**Final Drainage Report
U-Haul at Falcon
Falcon U-Haul Filing 1
El Paso County, Colorado**

Kiowa Project No. 21061

September 6, 2022

PCD File #
PPR-22-56

SHEET CONTENTS:
 DRAINAGE PLAN -
 PROPOSED CONDITIONS

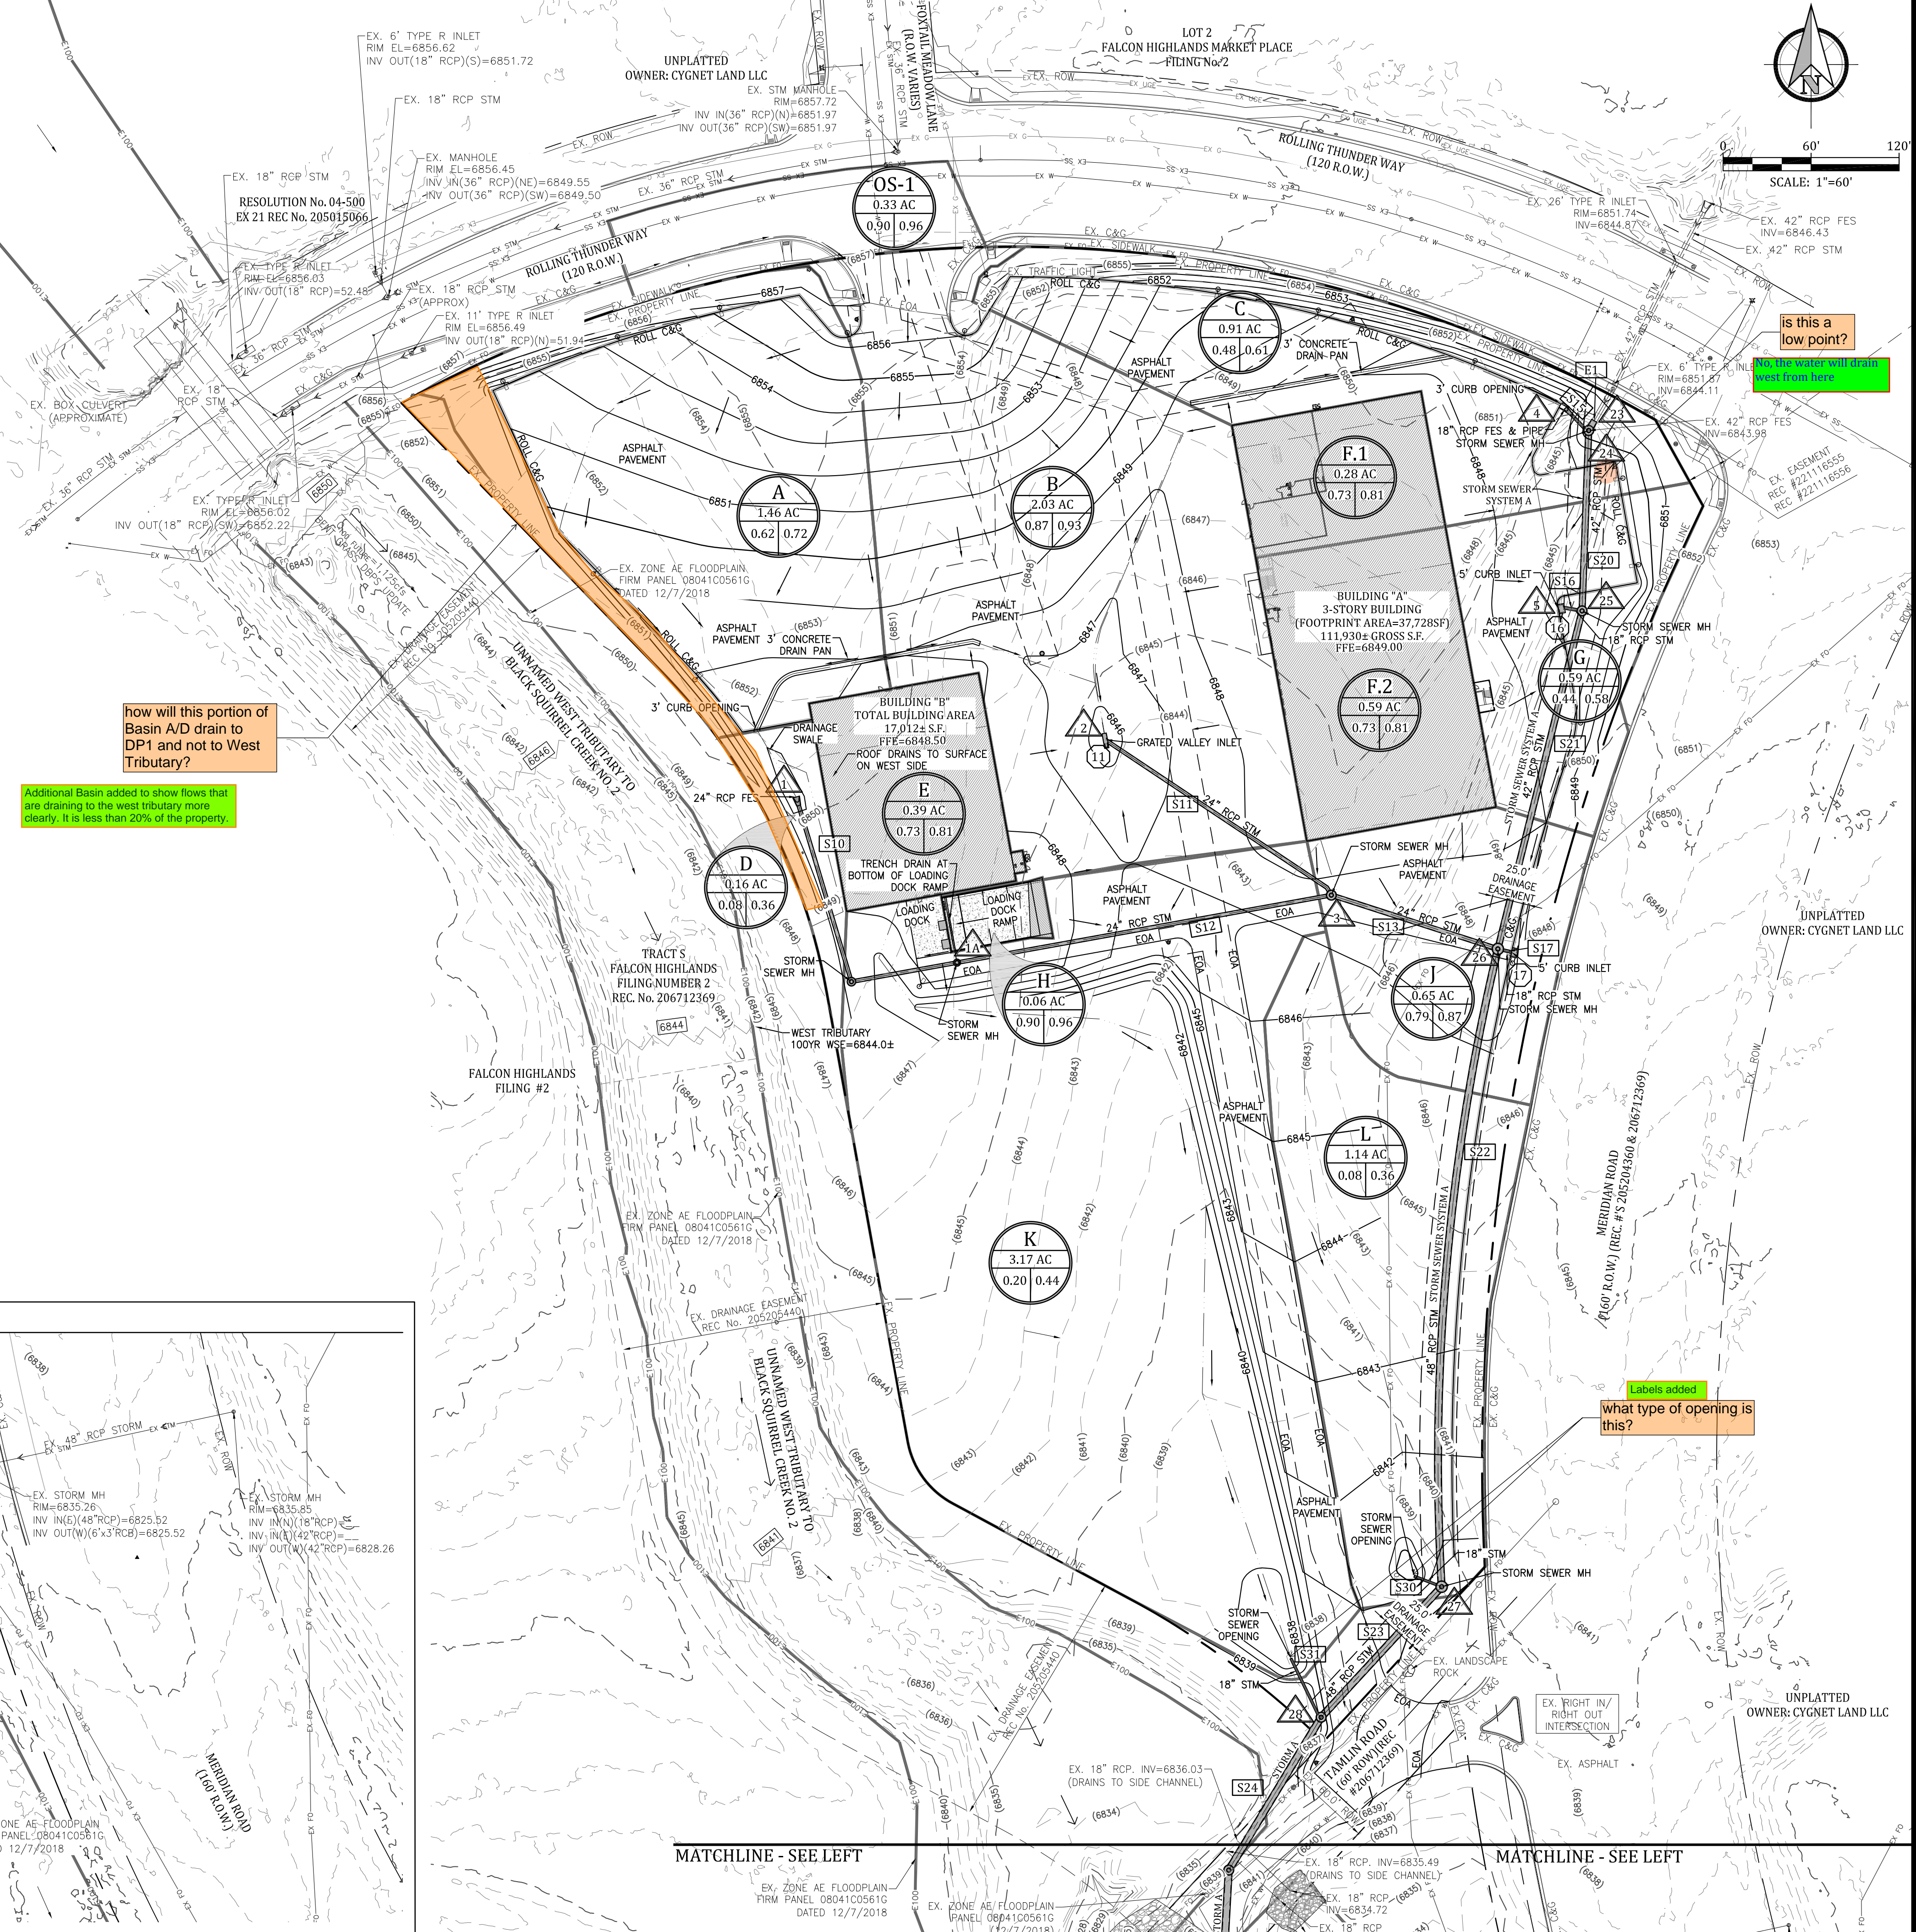
how will this portion of Basin A/D drain to DP1 and not to West Tributary?

Additional Basin added to show flows that are draining to the west tributary more clearly. It is less than 20% of the property.
